NOTICE TO CONTRACTORS - BID # 1415-143
BID TITLE "Carson City Animal Services Facility"
Labor Commissioner PWP# CC-2015-116
Engineer's Estimate: \$3,350,000
August 13, 2015

Addendum No. 1

CARSON CITY ANIMAL SHELTER
 549 Airport Road
 Carson City, Nevada 89701
 City of Carson City
 Copyright, 2015, BDA ARCHITECTURE P.C.

A1 ARCHITECTURAL FLOOR PLAN
 1/8"=1'-0"

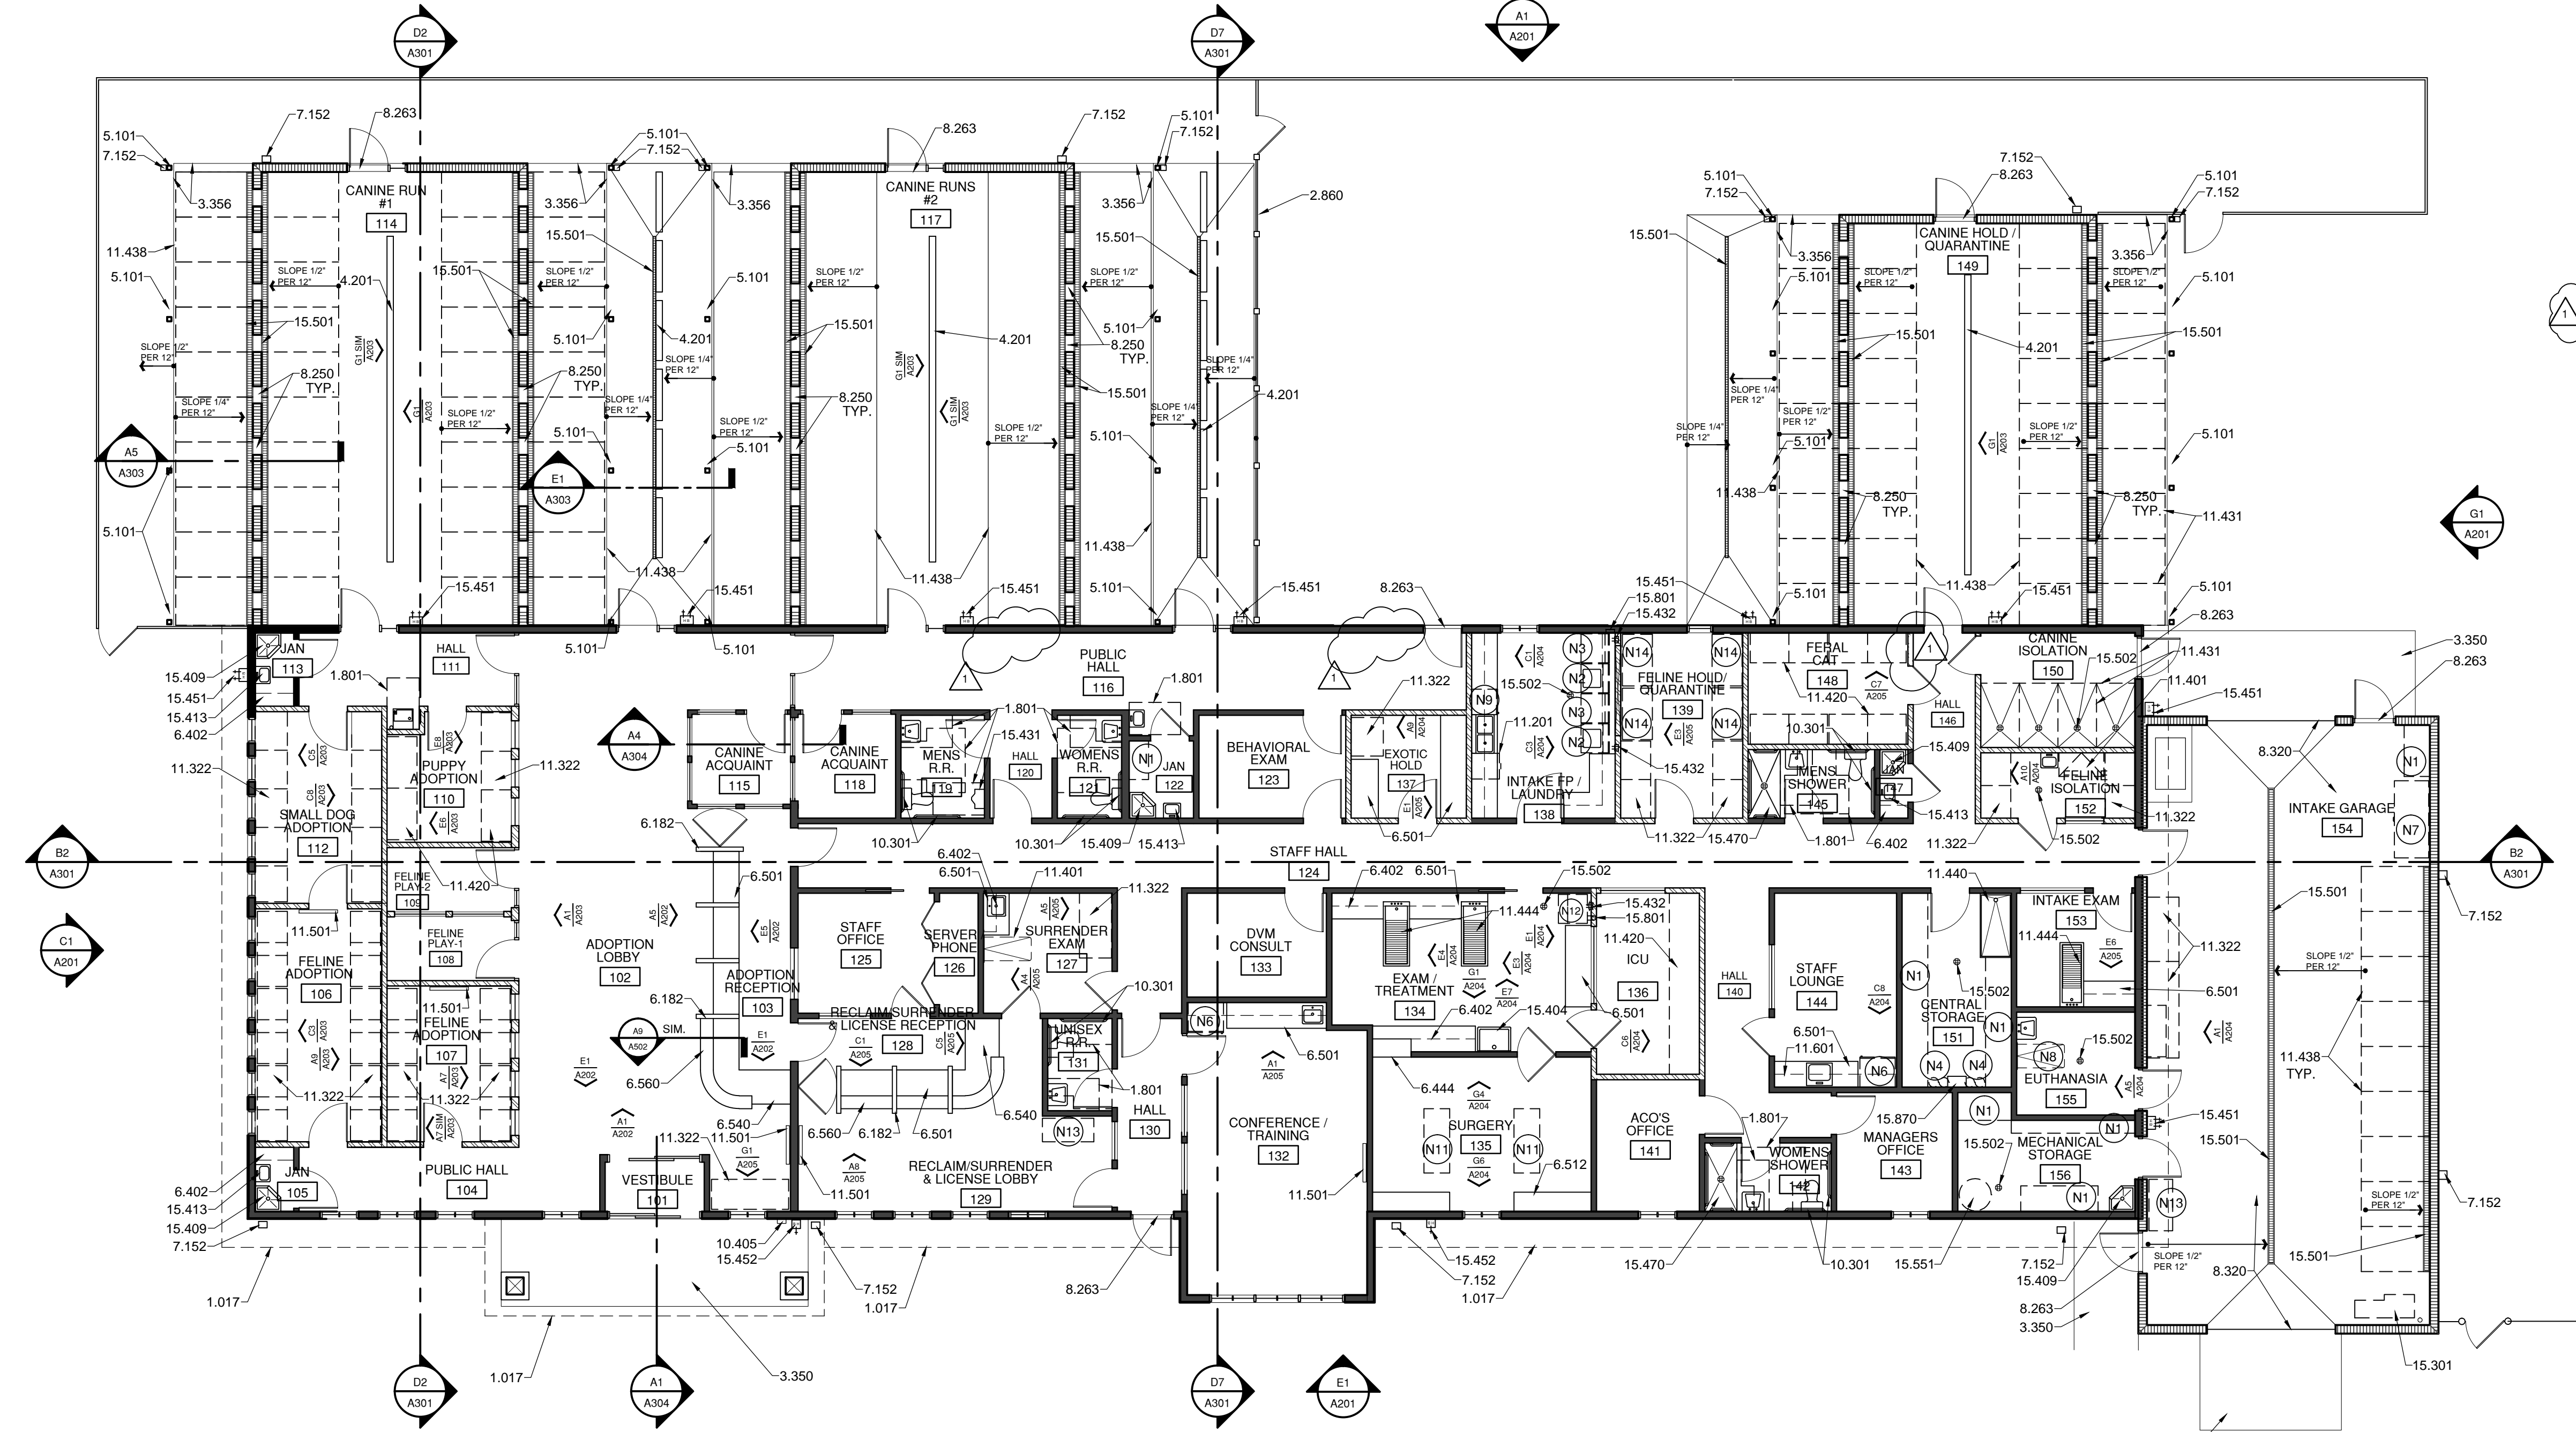
Cover Sheet: Revised Gross Usable Area:

Building – 6871 SF
Kennels and Garage – 3310 SF
Total - 10,181 SF

Sht A101 Clarified keynotes, removed reference to 15241-radiant floor manifold, updated usable area. See revised A101 sheet attached.

BUILDING AREA = 6,871 SF
 KENNEL PODS = 2,203 SF
 INTAKE GARAGE = 1,107 SF
 TOTAL 10,181 SF

P102

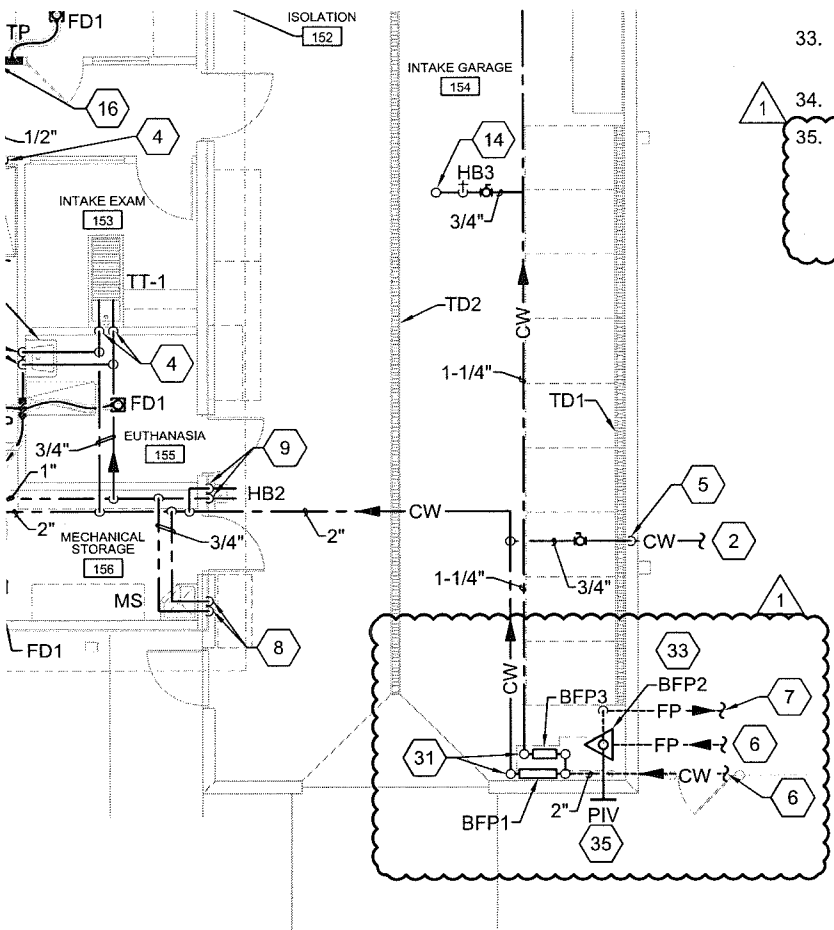
Sht P102 Addition of Post Indicator Valve, See 8.5x11 rev 1

35. PROVIDE WITH CROSS WALL POST INDICATOR VALVE(PIV) IN RISE BY TYCO FIRE PROTECTION PRODUCTS. LOCATE ON SOUTH WALL AT A VISIBLE LOCATION FROM STREET. PIV SHALL COME COMPLETE WITH THE GATE VALVE, POST BODY AND HAND WHEEL. PIV MUST BY LOCKED OPEN FOR NORMAL OPERATION. PROVIDE WITH HAND WHEEL LOCK AND CHAIN. SUPERVISE IF REQUIRED.
